California High-Speed Train Project

**RFP No.: HSR 11-16
Design Variance Report**

FRESNO STATION CROSSOVER DISTANCE FROM STATION
HST TRACK ALIGNMENT SPIRAL/VERTICAL CURVE OVERLAP
OCS CLEARANCE ASHLAN AVE
OCS CLEARANCE UNDER FUTURE RECONSTRUCTED FRESNO YARD OVERHEAD

DESIGN VARIANCE COVER SHEET

PROFILE

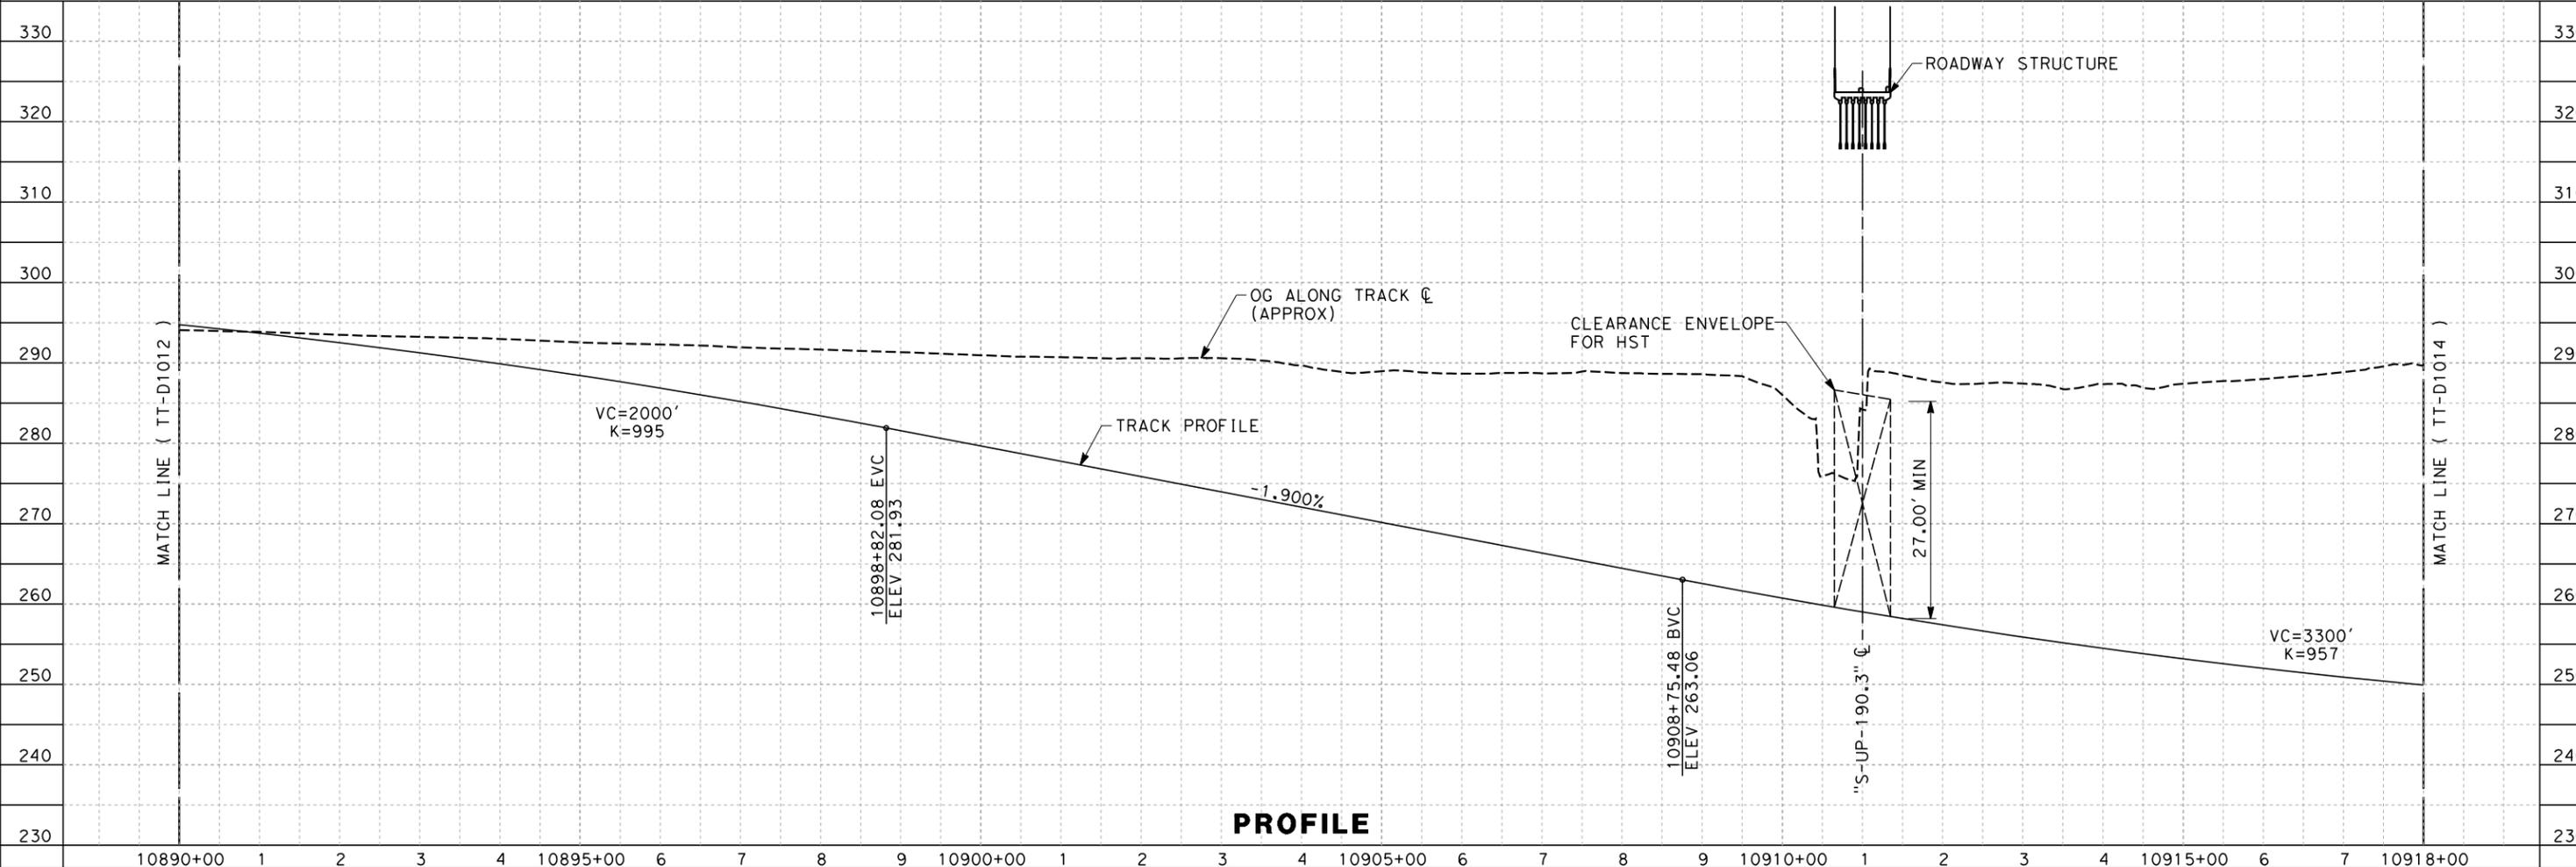
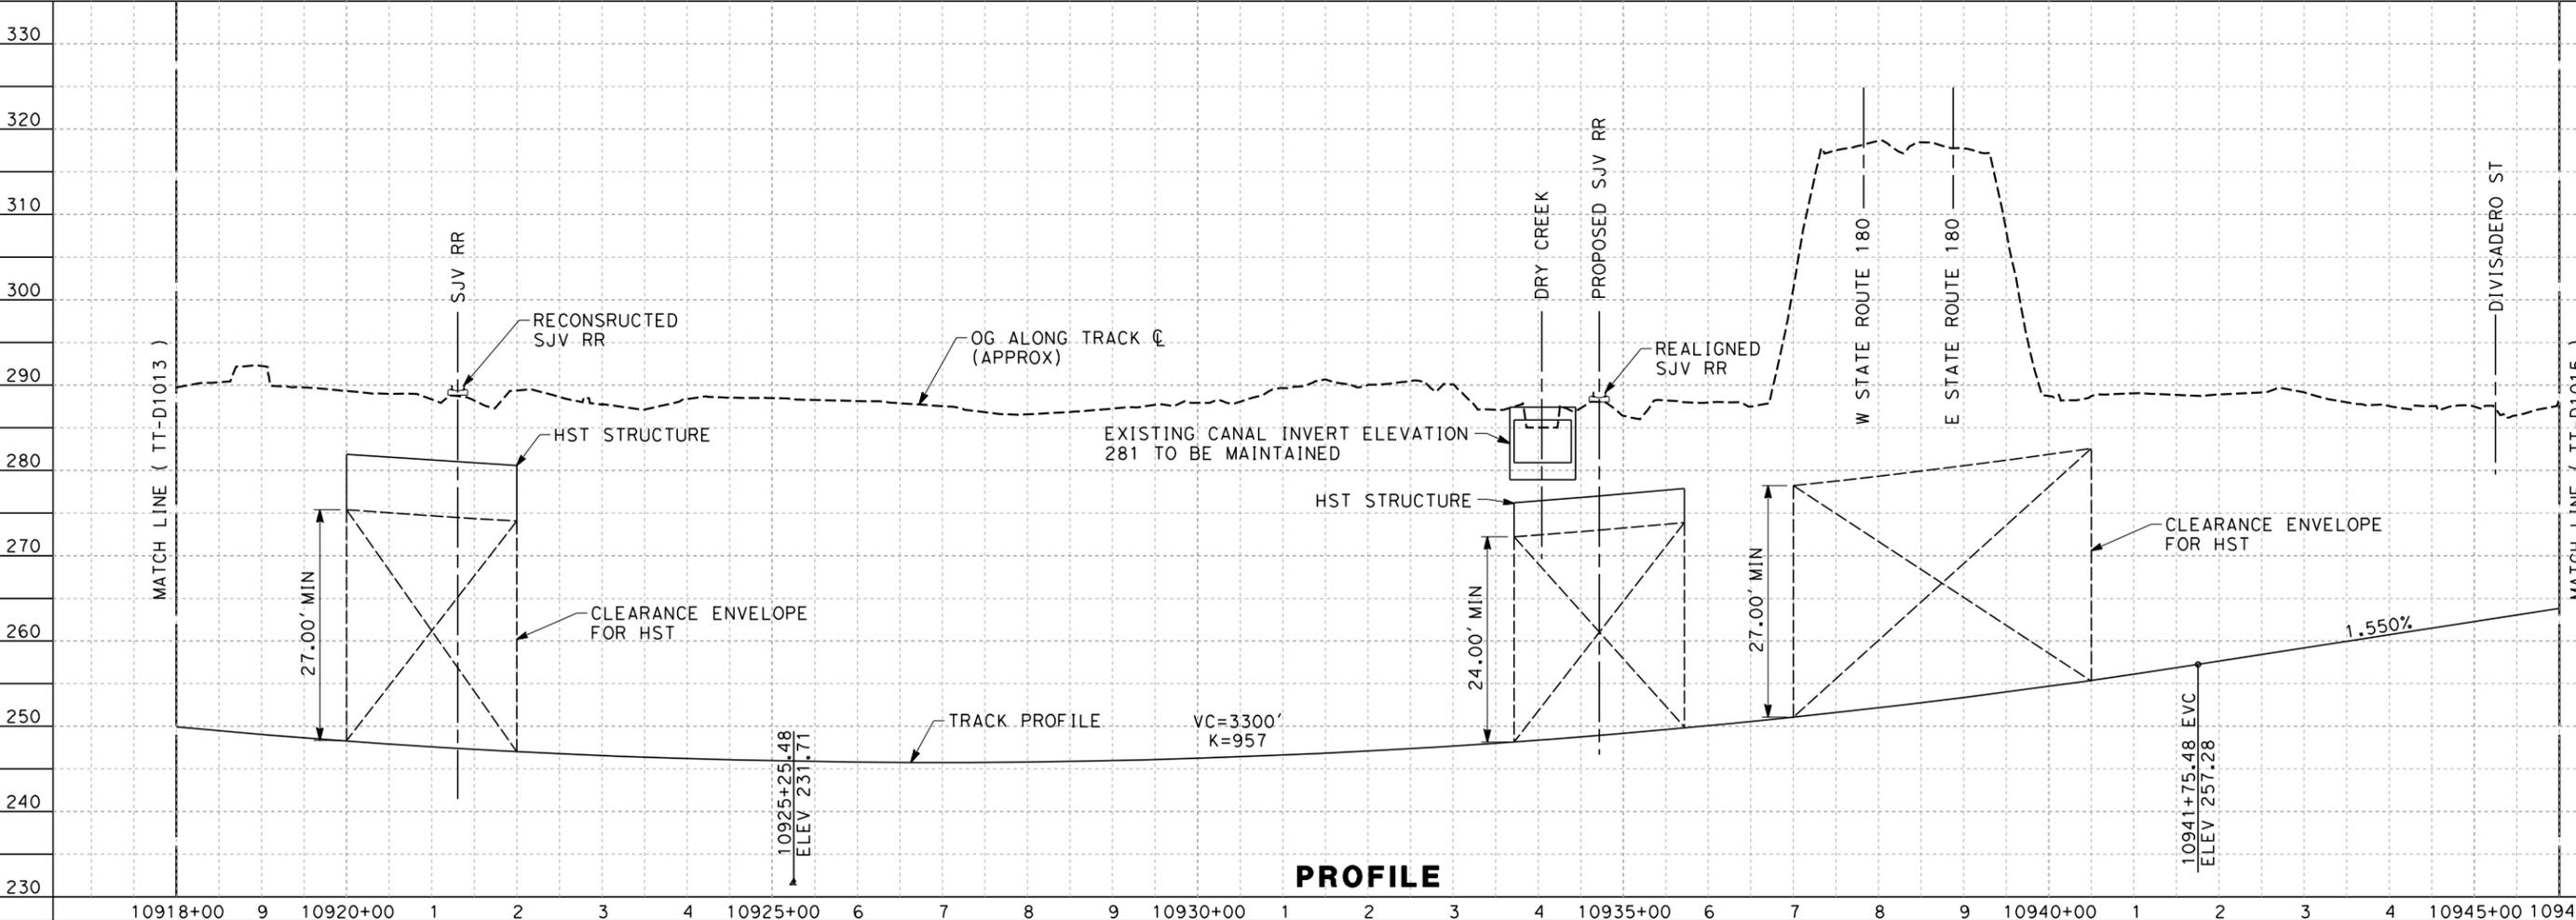
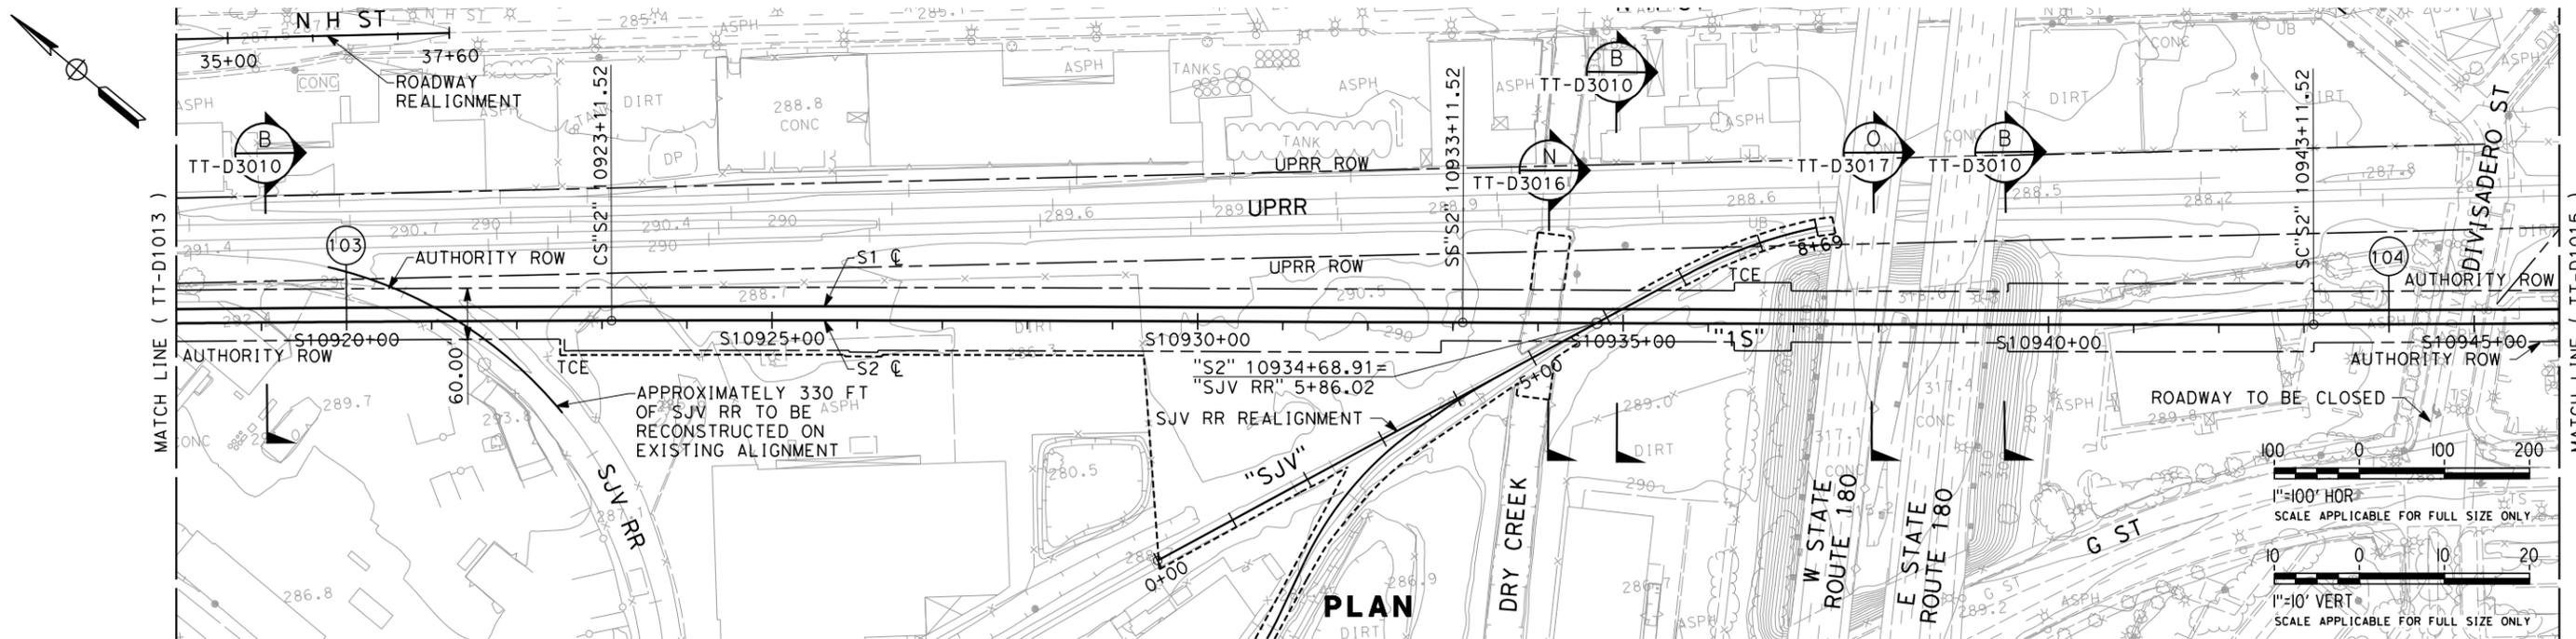
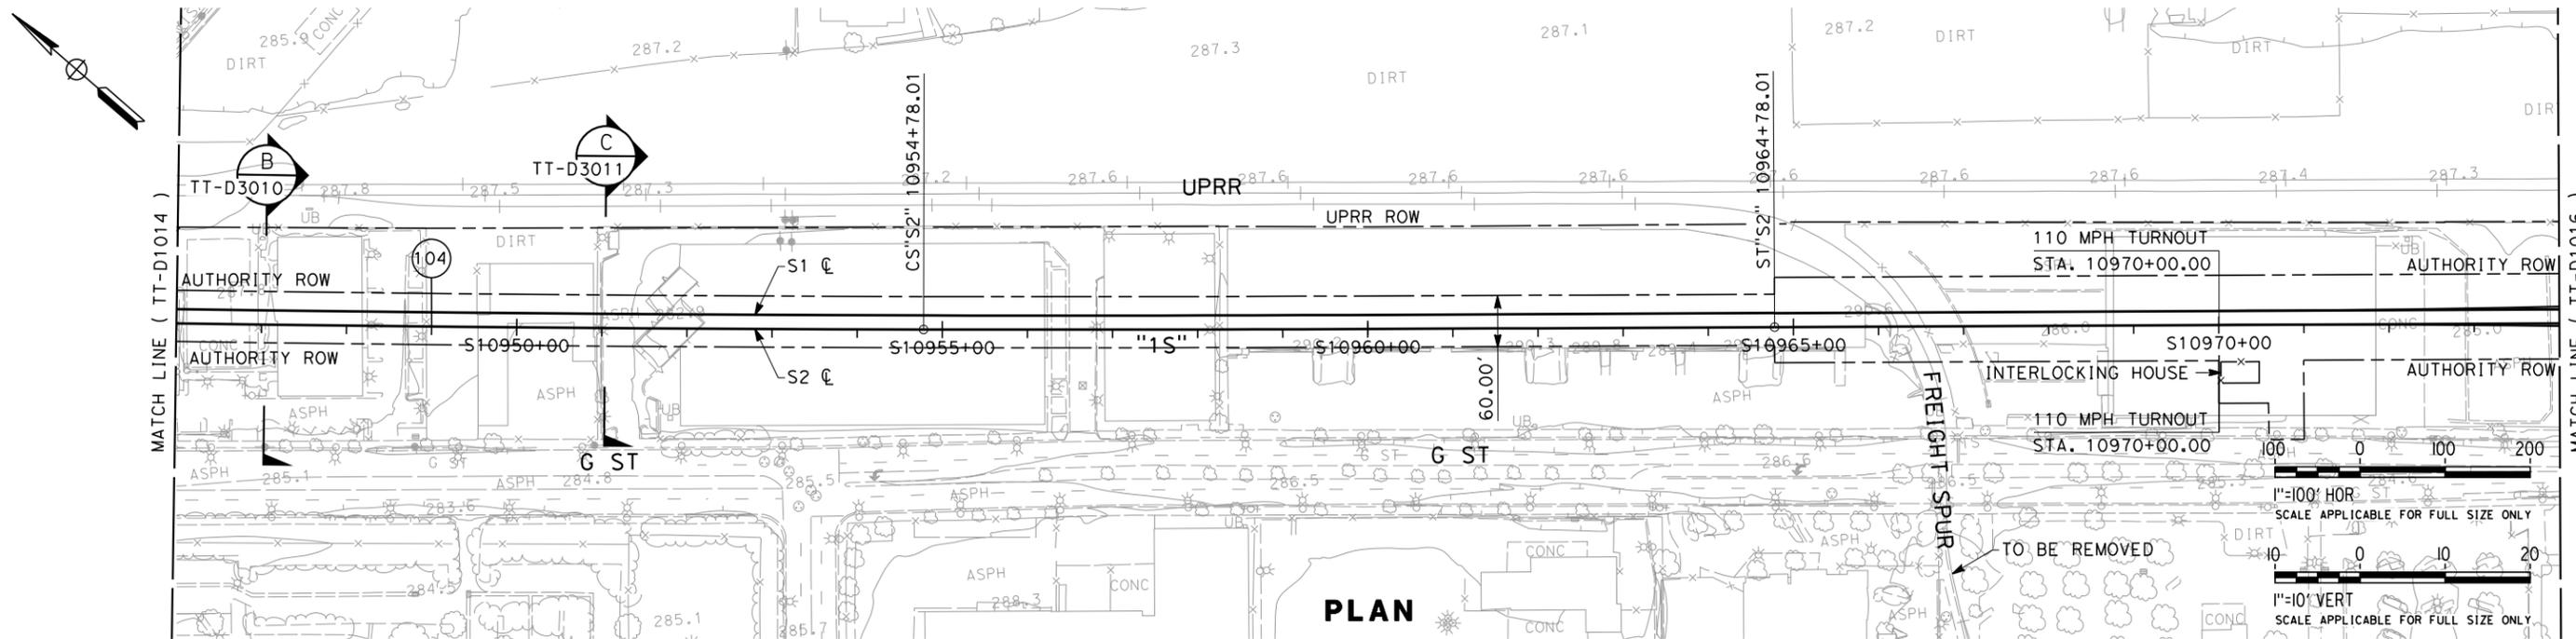
<p>CHSTP DESIGN REQUIREMENT Include reference to drawings, design criteria, technical memos, specifications</p>	<p>TM2.1.3 – Turnouts and Station Tracks Rev 0, 06/29/09 Figure 6.1.4 stipulates the desirable run time to determine the “minimum distance between the end of station turnout and crossover turnout, where they are on the same track,” should be 1.5 seconds, or a minimum of 1 second.</p> <p>Verbal advice from EMT stated that station crossovers should not be more than a mile from the station.</p>
<p>DESIGN CRITERIA REQUIRING A VARIANCE</p>	<p>Desirable run time to determine the “minimum distance between the end of station turnout and crossover turnout, where they are on the same track,” should be 1.5 seconds, or a minimum of 1 second.</p>
<p>REASON FOR REQUESTING A VARIANCE</p>	<p>Crossovers for Fresno stations at STA 10851+72.74 to 10863+11.37 and 108664+61.37 to 10876+00.00. Station platform ends are at 10970+00. This is a maximum separation of 14,127ft.</p>

<p>JUSTIFICATION FOR VARIANCE</p>	<p>Fresno Station is centered on Mariposa St and the station platform track approaches extend from Stanislaus St to the north and Santa Clara St to the south. The high-speed rail (HSR) descends into trench immediately after Stanislaus St in order to cross under abutments supporting the SR180 overcrossing of the Union Pacific Railroad (UPRR) tracks, spur tracks belonging to the San Joaquin Valley Railroad (SJVR) Company, and a canal that crosses under both the UPRR and the SJVR.</p> <p>The HSR is on a vertical curve as the tracks descend into the trench followed by a constant gradient of only 800ft at a gradient of 1.550%, followed by another vertical curve and then another section of 1,000ft at a constant gradient of -1.900%. The HSR emerges from the trench and is back at-grade on a constant gradient of 0.110% around 9,000ft (1.7 miles) to the north of the station platform turnouts. There are no sufficiently long sections at a constant gradient within the trench to accommodate a crossover with a design speed of 110mph (i.e., 1,139ft).</p>

<p>PROPOSED ALTERNATIVE DESIGN</p>	<p>Continue an at-grade alignment between W</p>

REQUIREMENT	<p>Olive and the station. This would require grade separation junction to carry the SJVR spurs (if feasible) and closure of Dry Creek. SR180 would require major works to the embankments and probable reconstruction of the abutments of the bridge crossing UPRR.</p> <p>It may be feasible to provide a crossover on the 1,000-foot section of constant gradient within the trench, but this would require the imposition of an 80mph speed restriction due the short crossover. This option was not recommended.</p>
--------------------	--
